SKETCH PLAN
 FOR
MURPHY HOMES
 CITY OF COATESVILLE- CHESTER COUNTY - PA

**RE: Murphy Development, LLC, , 442 Mount Pleasant Street
Preliminary Subdivision and Land Development Review
442 Mount Pleasant Street, Parcel 16-4-3
Project No: T&M-12-009/COAT-R0040**

CEDARVILLE Engineering Group, LLC, on behalf of T&M Associates, has reviewed the materials provided by Mullin Engineering LLC., application for Preliminary Plan requirements for the Murphy Development, LLC. project on Mount Pleasant Street.

GRADING PLAN

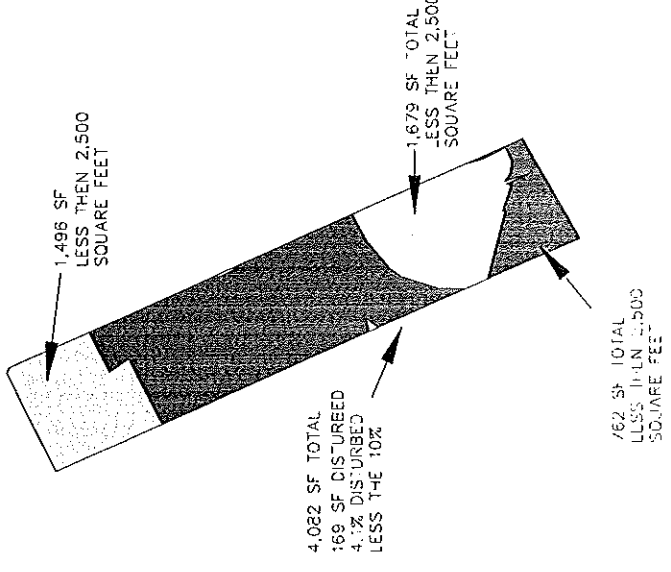
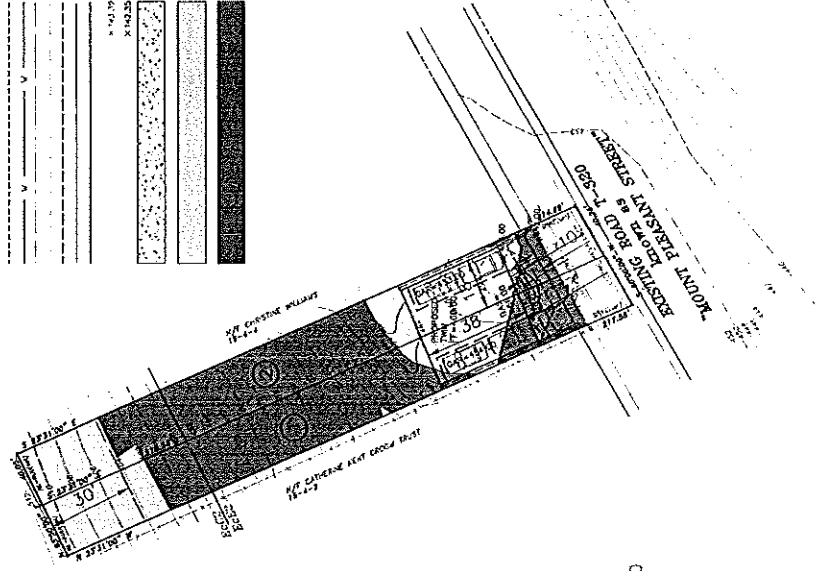
The proposed grading plan indicates the directing of stormwater runoff from the rear hillside to the adjacent properties which is not permissible. The construction details on the site plan indicate there is an infiltration pit that is not shown in plan view.

Applicant shows a 6% grade at the curb which exceeds the maximum grade of any driveway within the right-of-way of any street shall be 4%. Applicant must revised the grading within the right-of-way to meet the maximum grade requirement. Grading for the complete length of the driveway must be provided for review and approval.
